ENCLOSURE 1

Proposed Technical Specification Changes

3/4.7.4 ~~SNUBBERS DELETED~~

ENCLOSURE 2

FIGURE 4.7.4.1
SAMPLE PLAN FOR SNUBBER FUNCTIONAL TEST

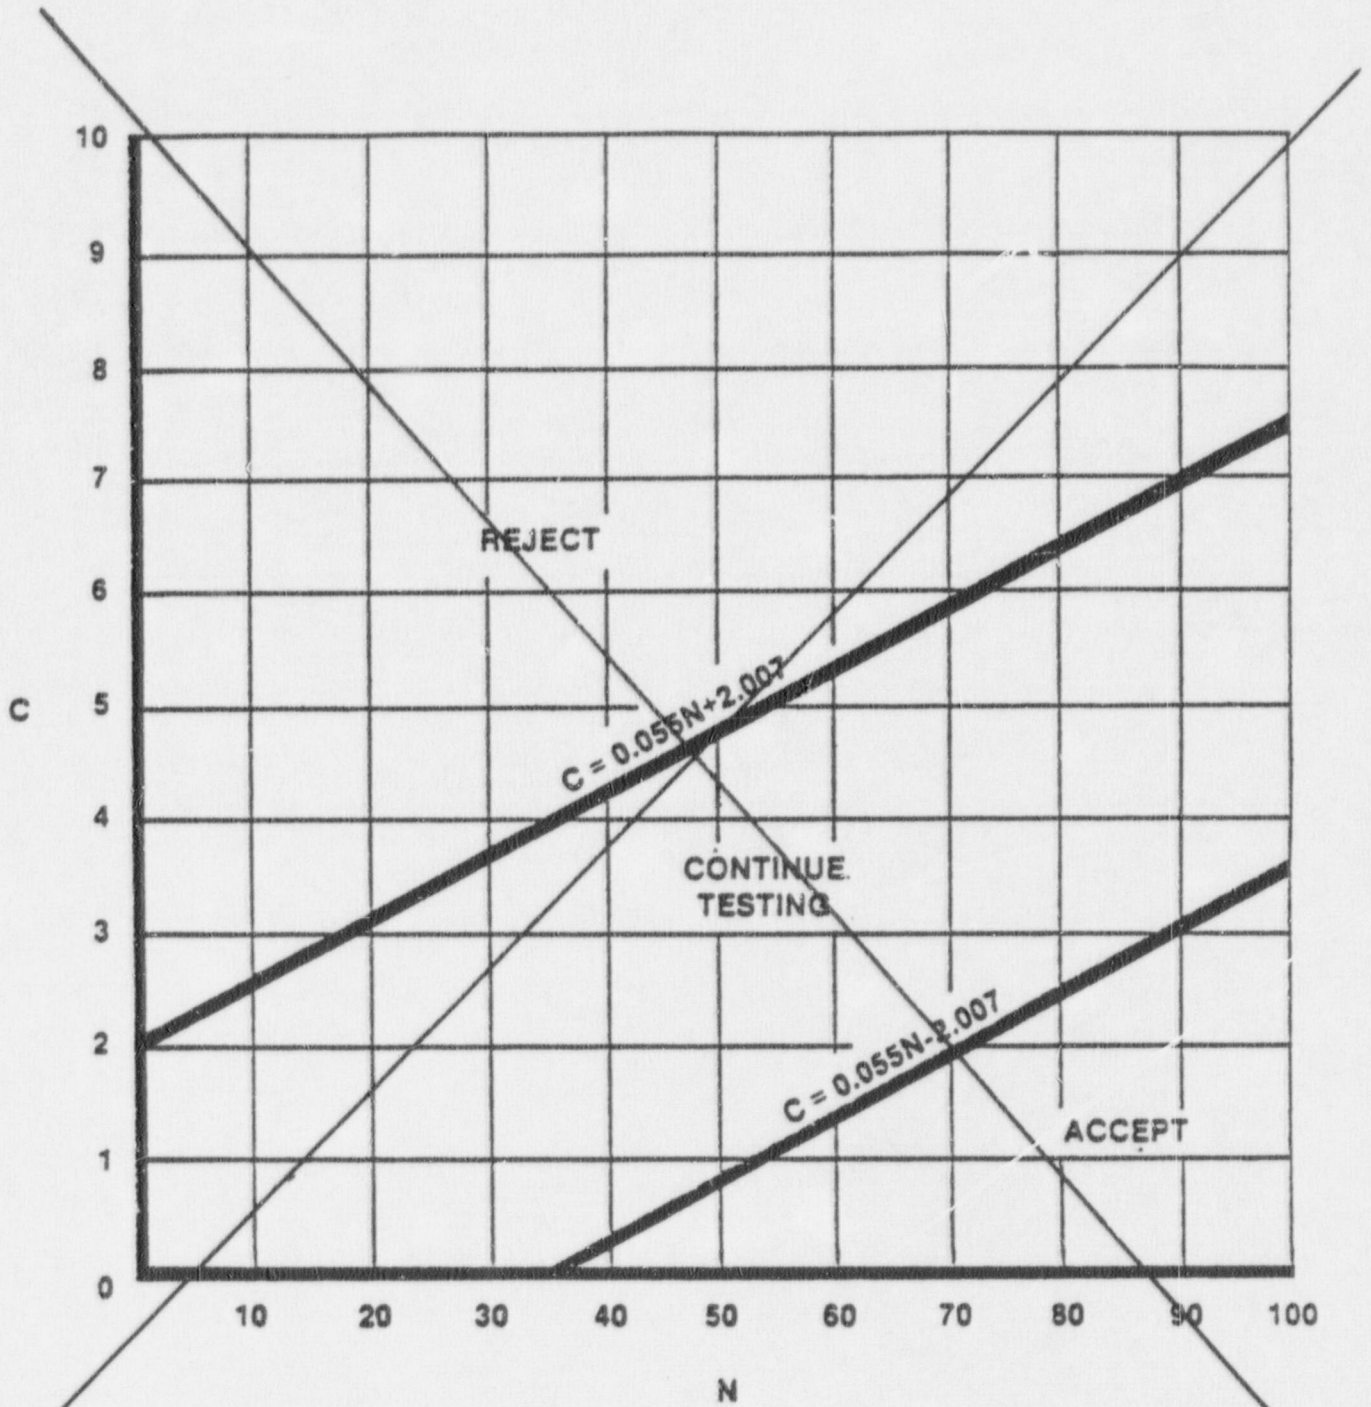
DELETED
